Tennessee Valley Authority, 1101 Market Street, LP 5A, Chattanooga, Tennessee 37402-2801

NUCLEAR REGULATORY COMMISSION (NRC) – BELLEFONTE NUCLEAR PLANT (BLN) – RESPONSE TO NRC INFORMATION NEEDS RELATED TO CULTURAL RESOURCES

ENCLOSURE – RESPONSE TO NRC INFORMATION NEEDS – CULTURAL RESOURCES

AERIAL PHOTOGRAPH BELLEFONTE SITE AND PROJECT AREA OF POTENTIAL EFFECT

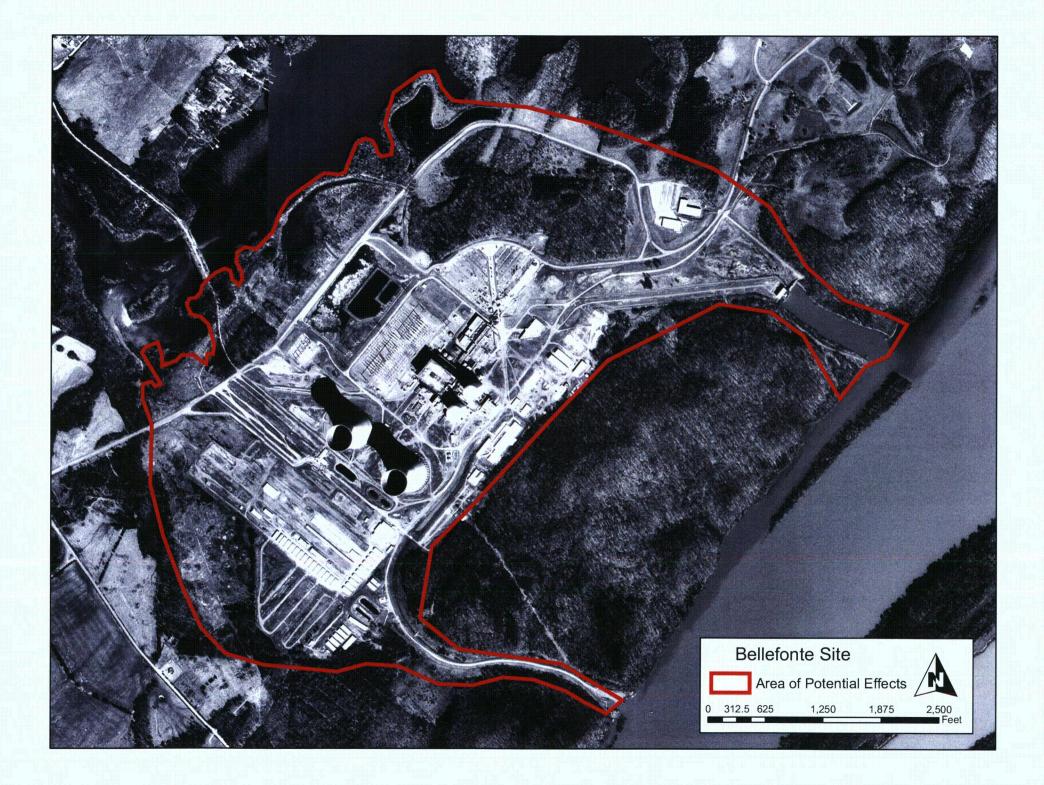
- **CR-10:** Provide current aerial photographs of BLN site, if available.
- **CR-15:** Describe process for determining APE.

A current aerial photograph of the BLN site, with the project area of potential effect (APE) superimposed, is provided as Attachment A to this letter.

Aerial Photographs Bellefonte Site Under Construction (1977 – 1981)

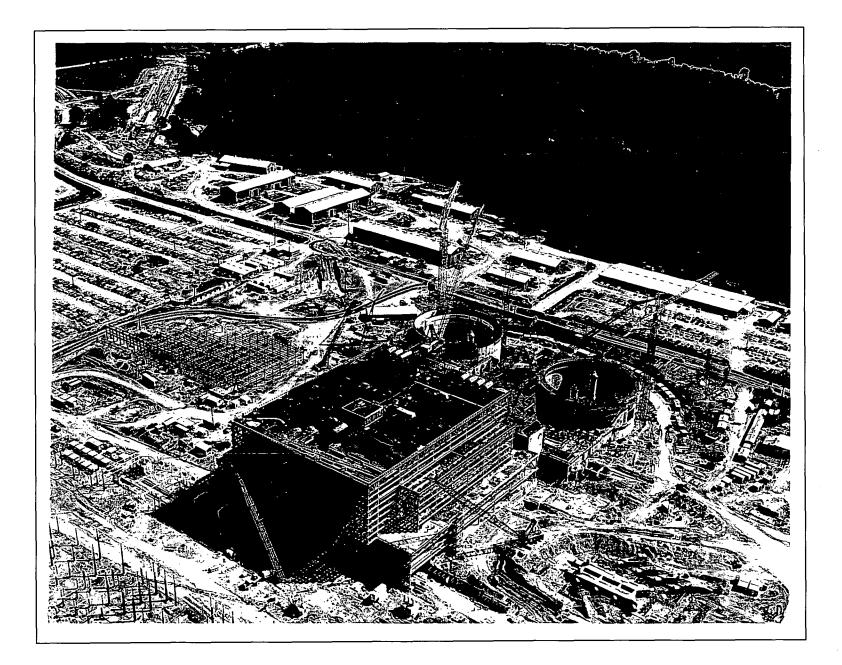
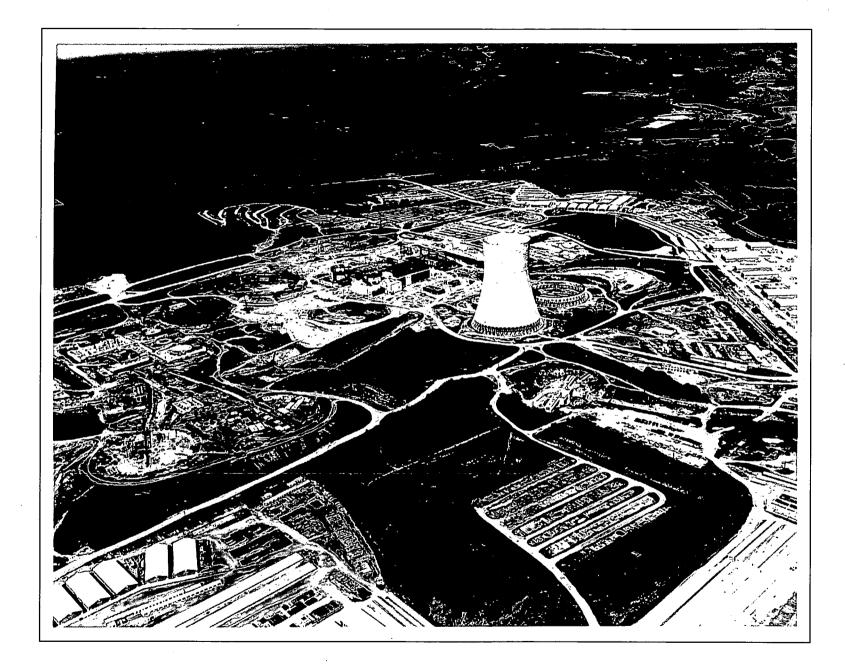
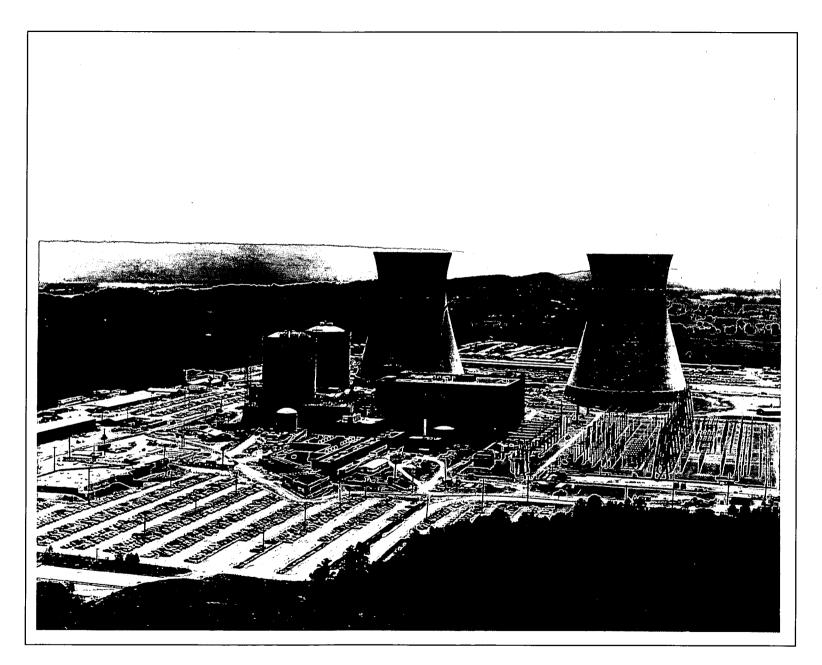
CR-11: Provide historic aerial photographs of BLN site showing extent of construction disturbance, if available.

Three aerial photographs showing the Bellefonte site during construction of the Bellefonte Units 1 and 2 reactors, cooling towers, and other facilities are provided as attachments to this letter. These photographs depict the extent of construction disturbance in October 1977, June 1981, and during the interim period between these two dates.
